# Edmondson Park Sites 1-3

## Response to DEP Comments

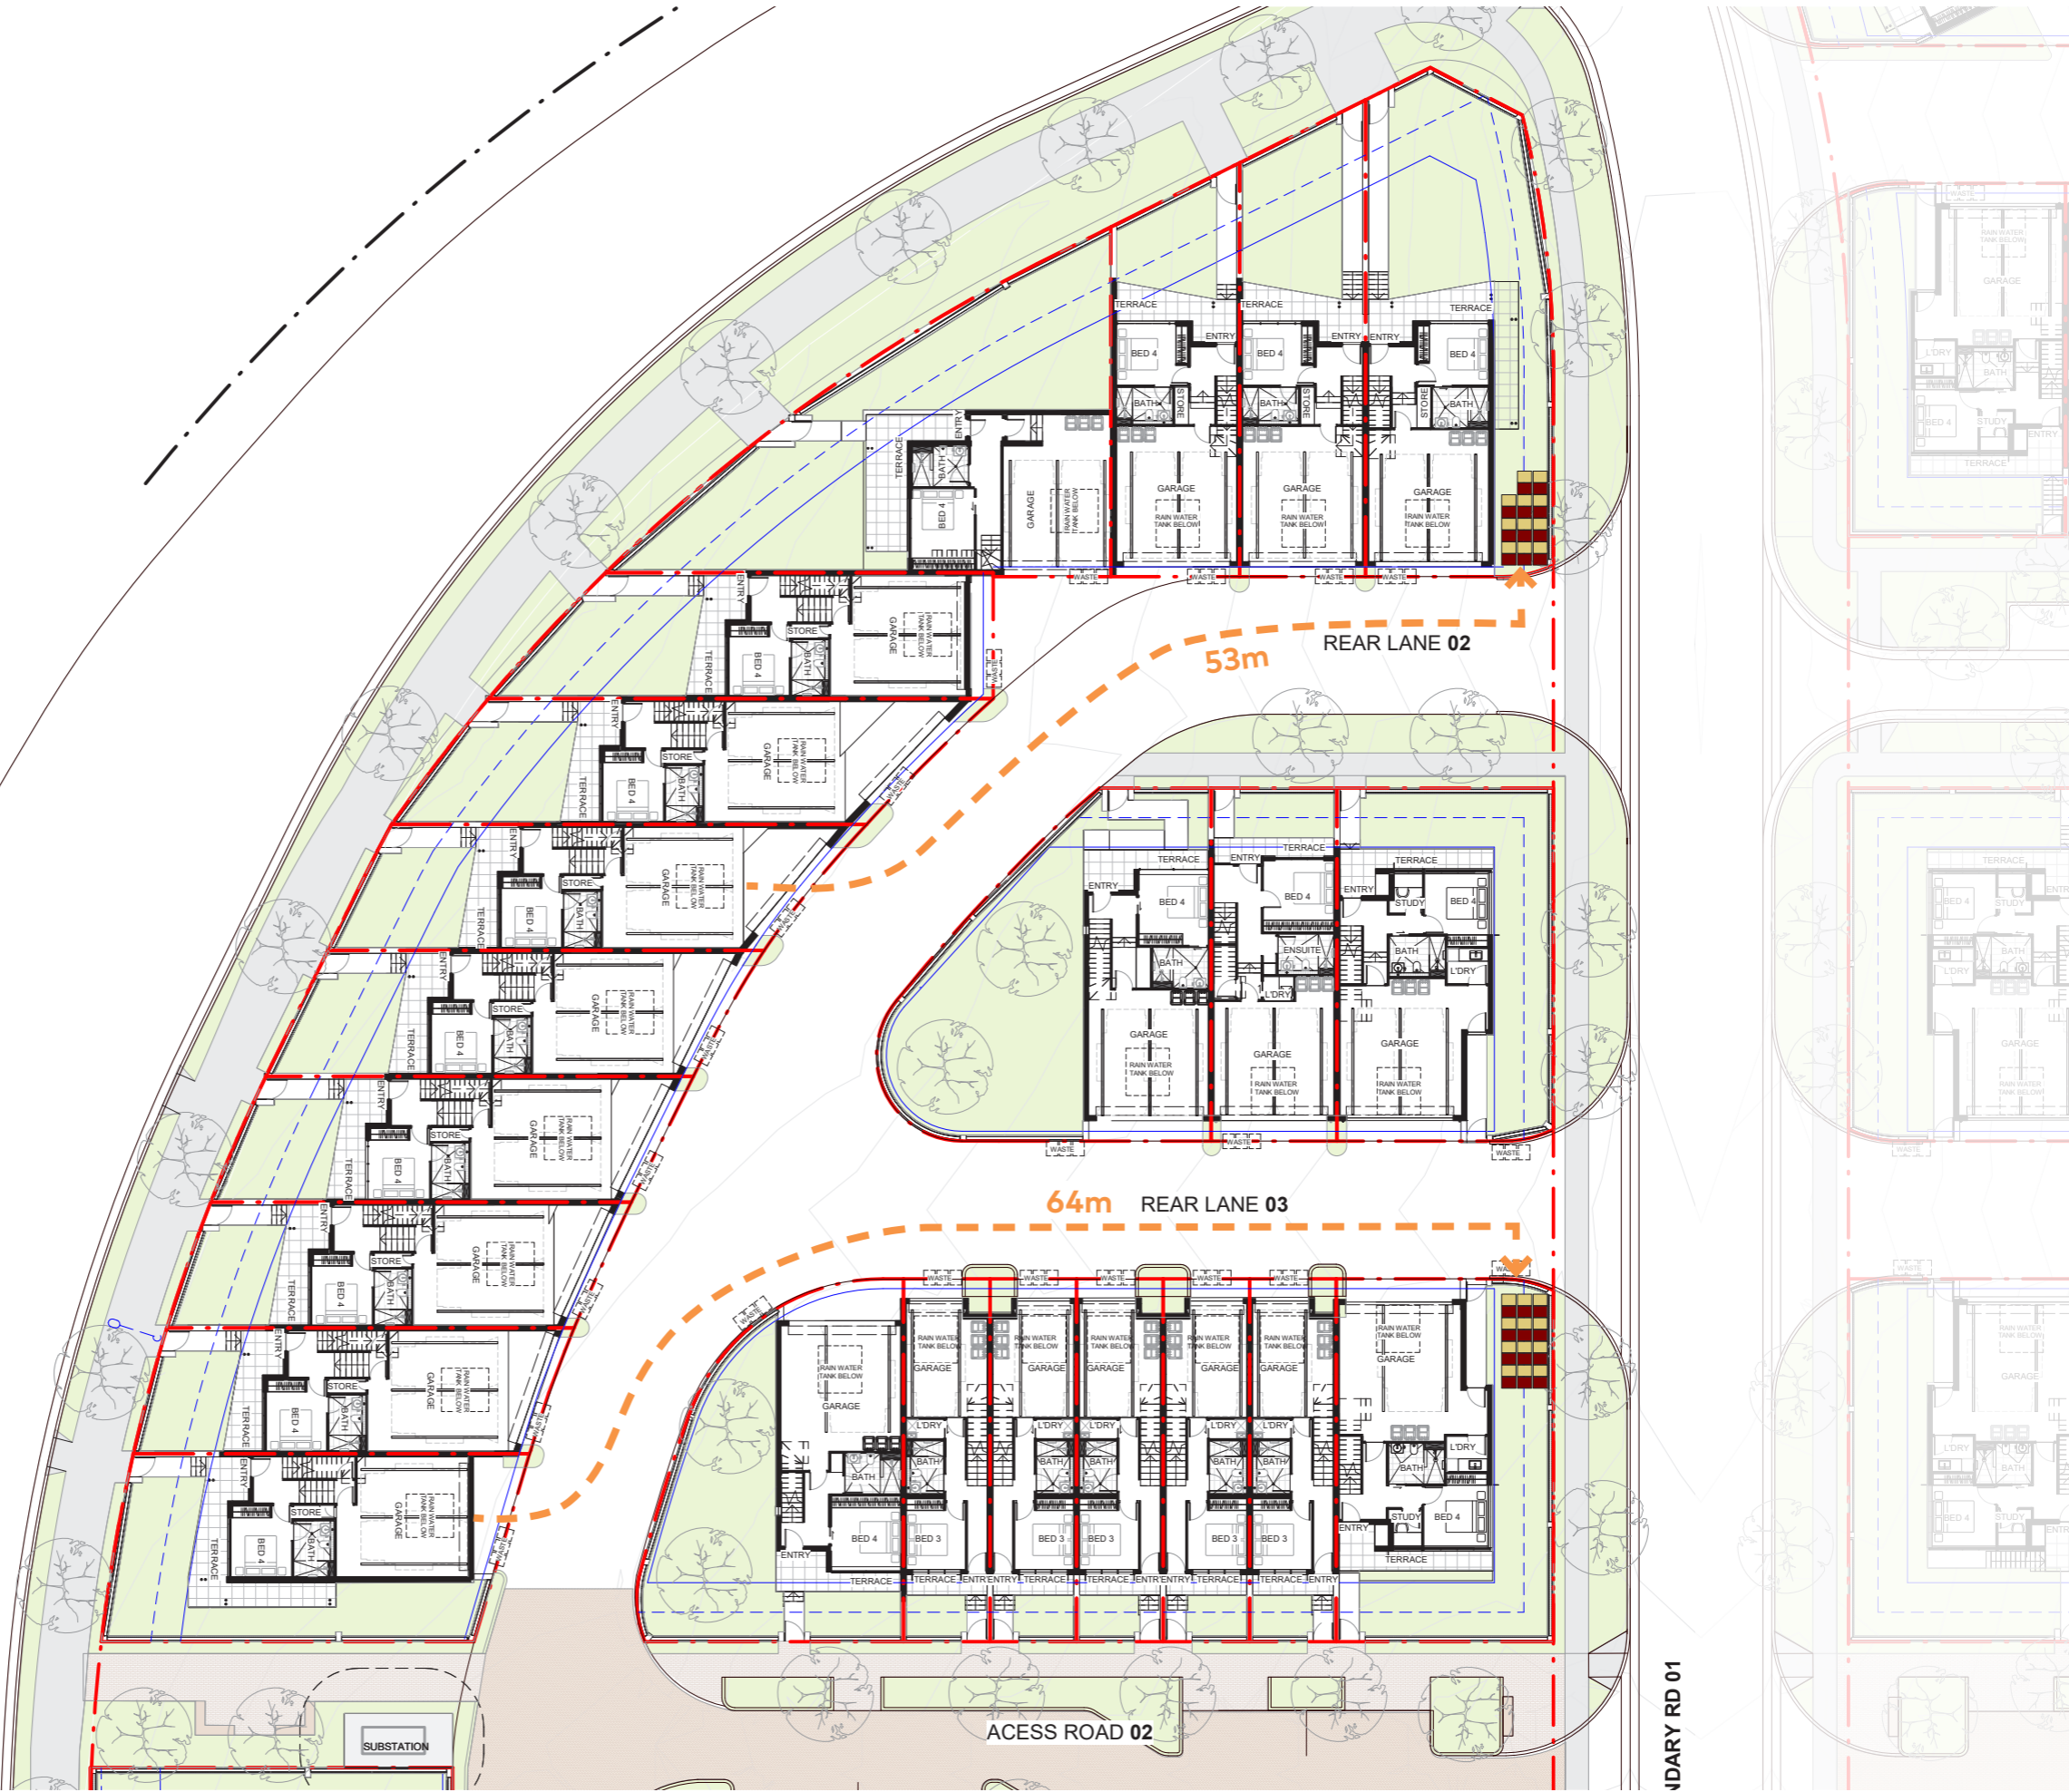
"The Panel requires the applicant to judiciously review the bin collection and fire truck access requirements. The Panel acknowledges that the current width of the laneways is governed by Council's servicing requirement of garbage trucks, however, the Panel recommends creating a consolidated space towards the ends of terraced blocks for bin pickup, as was demonstrated in the drawings for DA-1090/2022.

The Panel emphasizes that additional space for sustainable landscape works can be achieved by decoupling the bins and the fire truck movement with the laneways. This would also alleviate the separation and privacy issues between bedrooms across the laneways, whereby additional canopy coverage can help achieve screening (see image below for reference – centralised collection points marked in red circles). These collections points should be screened to preserve visual amenity along the street."

Figure 4.11 provides a graphic scenario where Bin Storage / collection points are provided at the end of each laneway (as suggested by the DEP). This suggestion can create up to 64 meter of travel in the portion shown in Figure 4.1.1. It is important to note that the lanes accessing the Bin Storage / Collection points are sloped. The fall ratio ranges between 1:17 to 1:24, which required homeowners to carry waste up and downhill.

Fig 4.1.20 Ground Floor  
Amended Pedestrian Link Buchan Ave

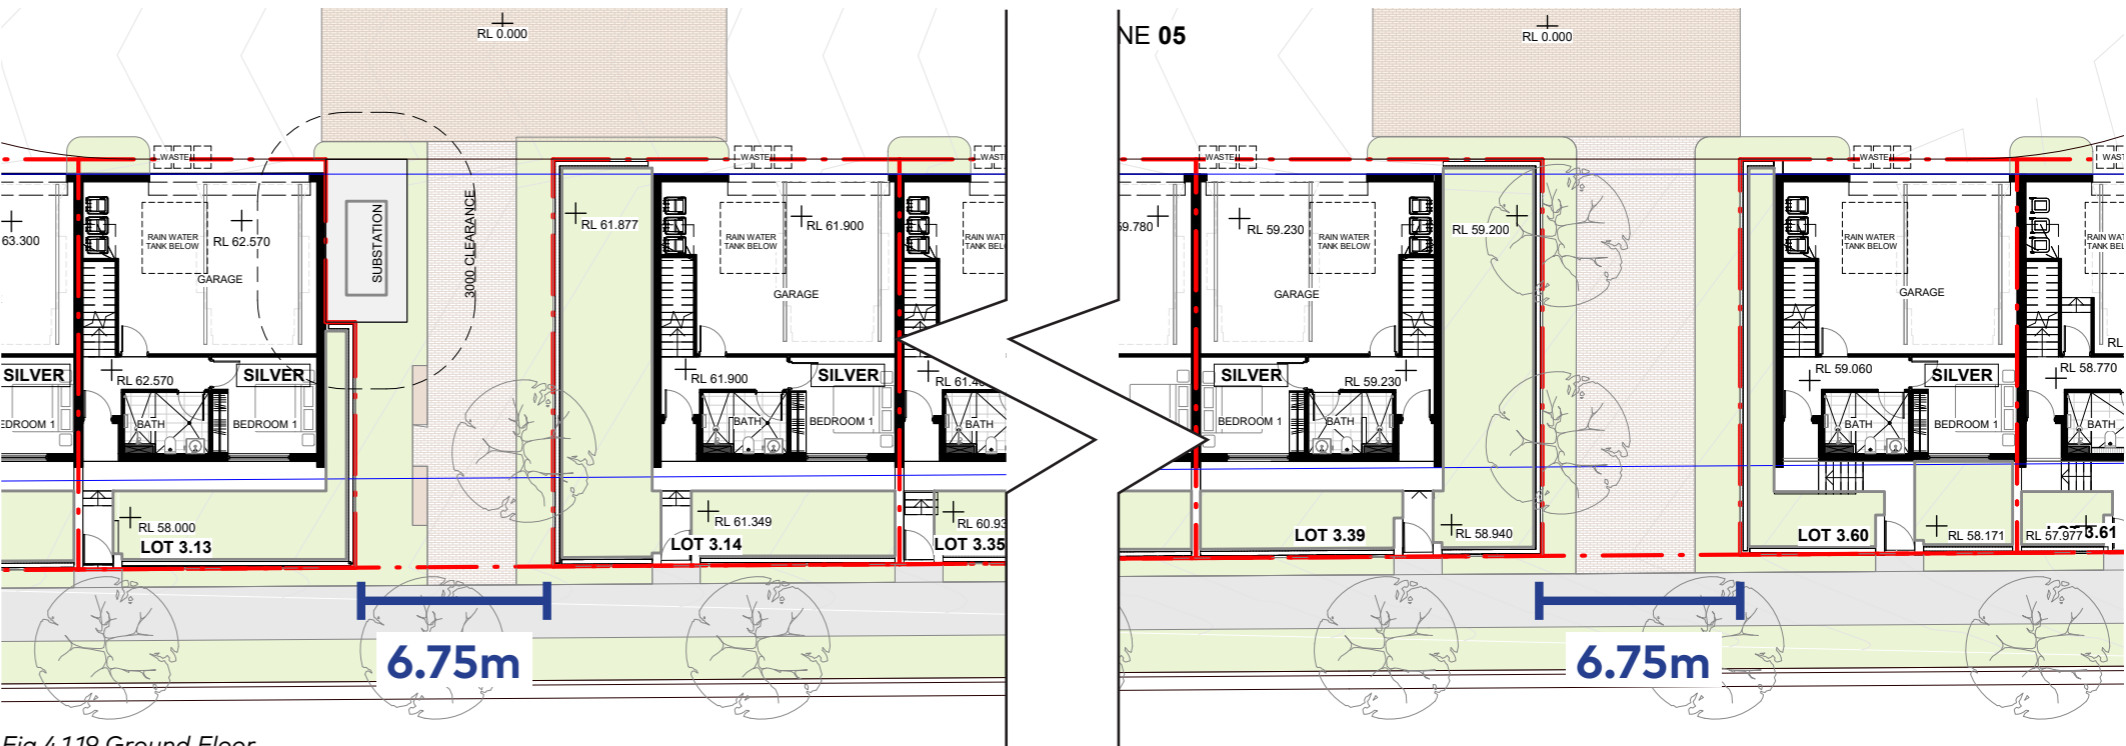
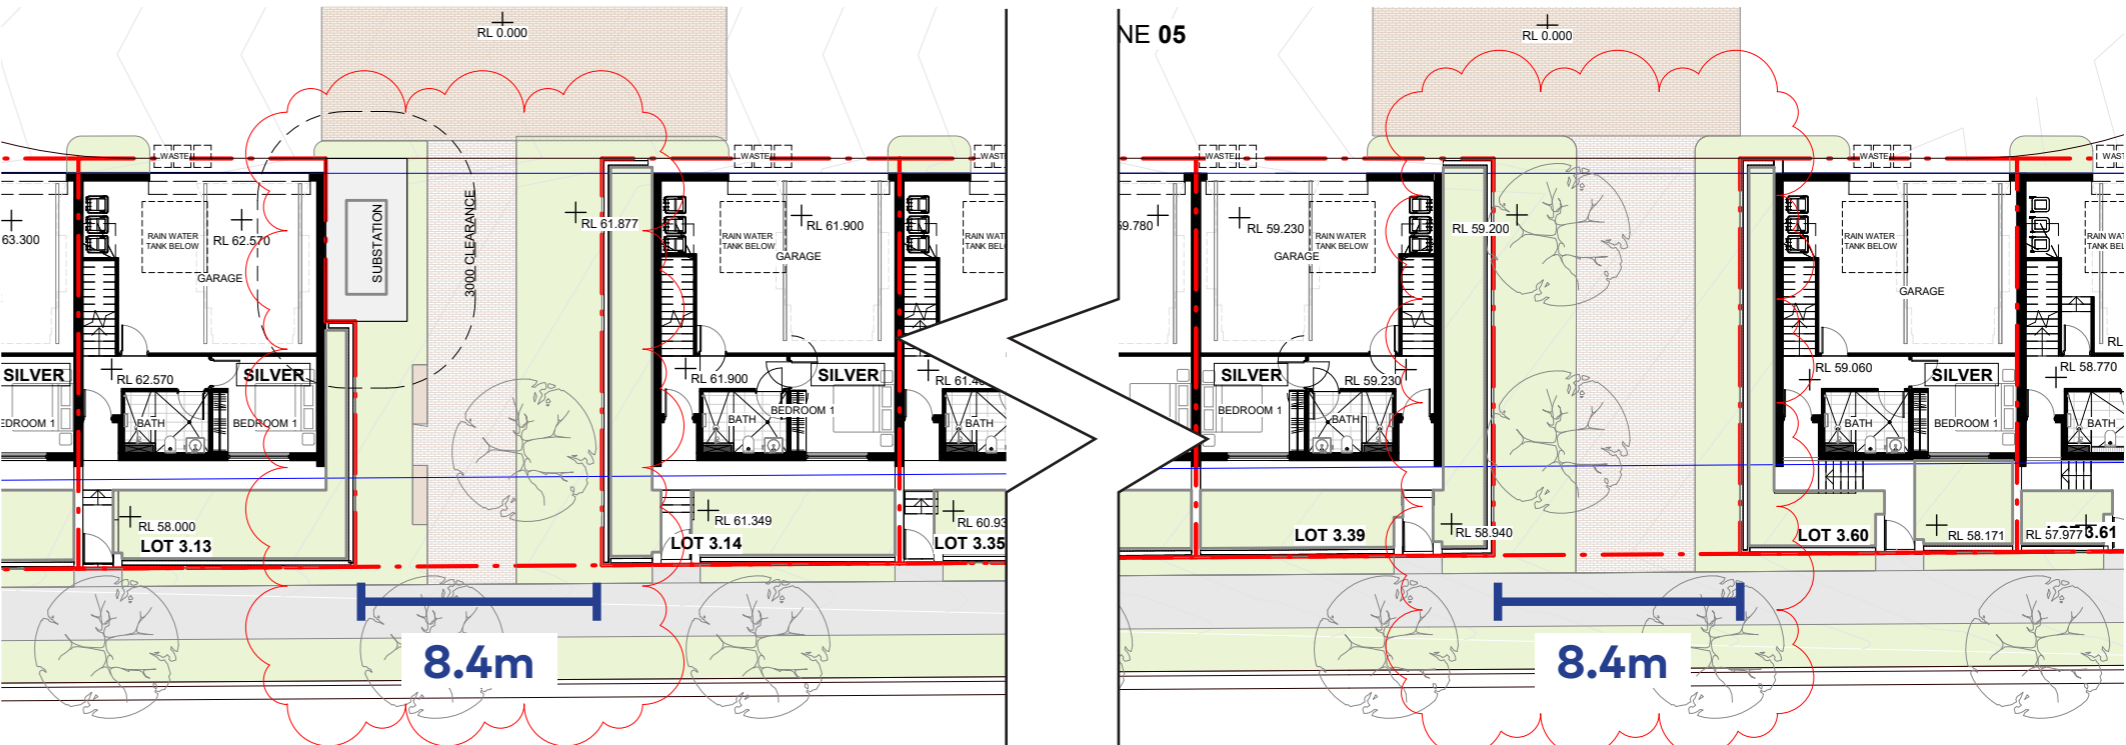
"The Panel requires the applicant to extend / align the width of Access Road 02, 03 and 04 across to Bezentin Ridge Road and Buchan Ave with the terraced blocks (see image below – marked in blue). This would achieve a wider visual connection across the two streets and can be used as communal spaces / pocket parks as part of the development. The Panel acknowledges that the applicant raised issues with stormwater drainage in these areas and the widening of these connections, however that was not fully understood from the explanation given in the meeting, and it was questioned how substations could be located in areas affected by overland flow."

In alignment with this suggestion, the Terraces adjacent to Buchan Ave pedestrian links have been revised to increase the width of the community title landscaped area.

The width of these spaces have been increased from 6.75m to 8.4m, as shown in Figures 4.1.19 to 4.1.29 on the following pages which demonstrates these increase in widths.

Future provision of Lift

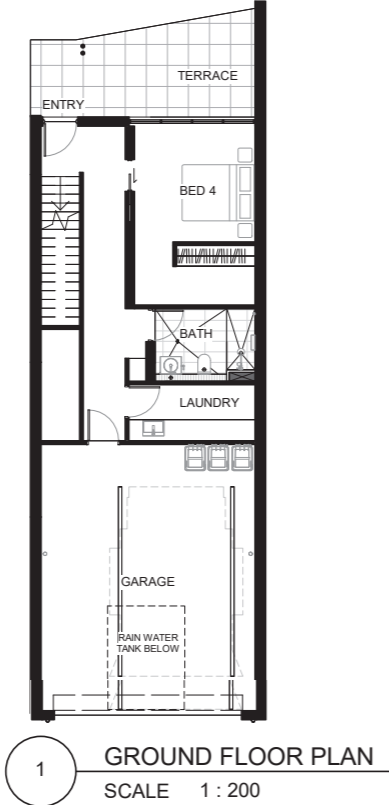
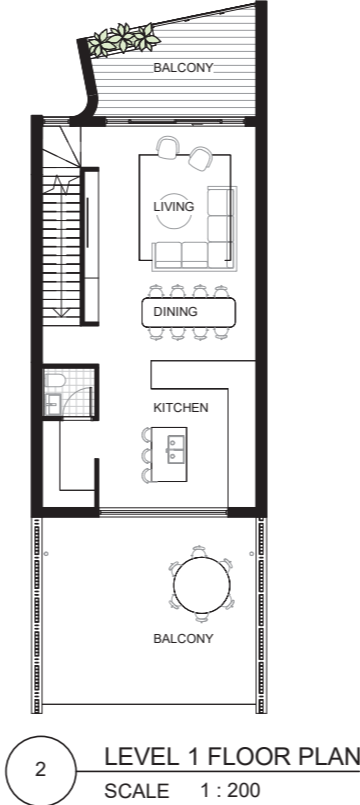
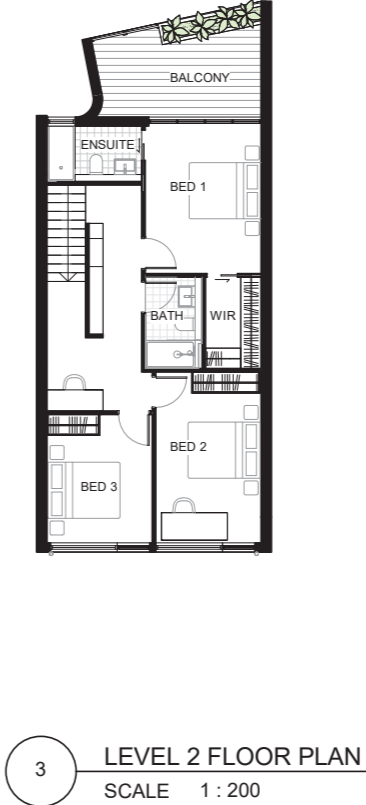
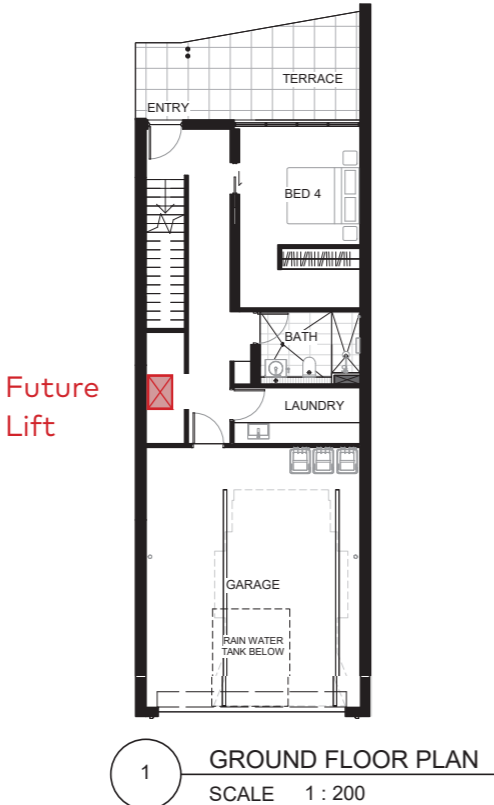
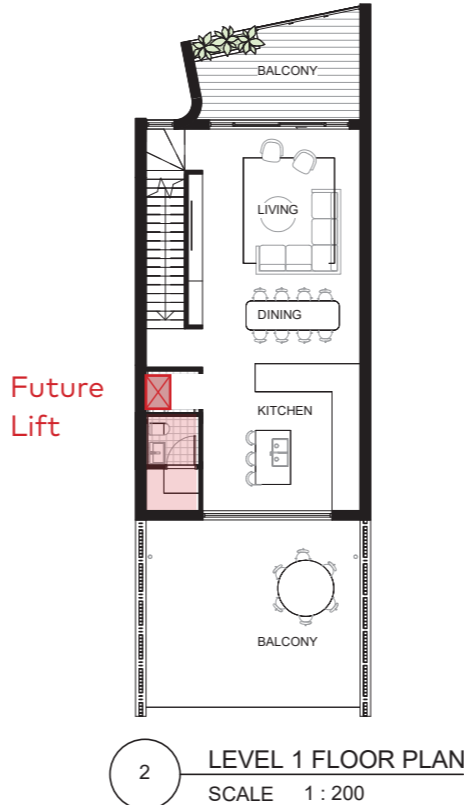
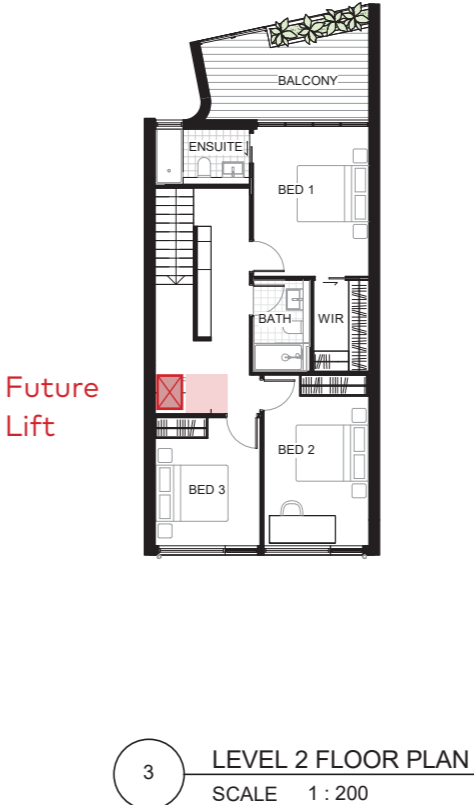
"The Panel recommends the applicant to consider future provision of vertical circulation for these terraces. Provide a future location to install lifts within these terraces to enable ageing in place ."

On the coming pages, Terrace types K and O have been identified as easily modified layout to provide lift access in the future if needed.
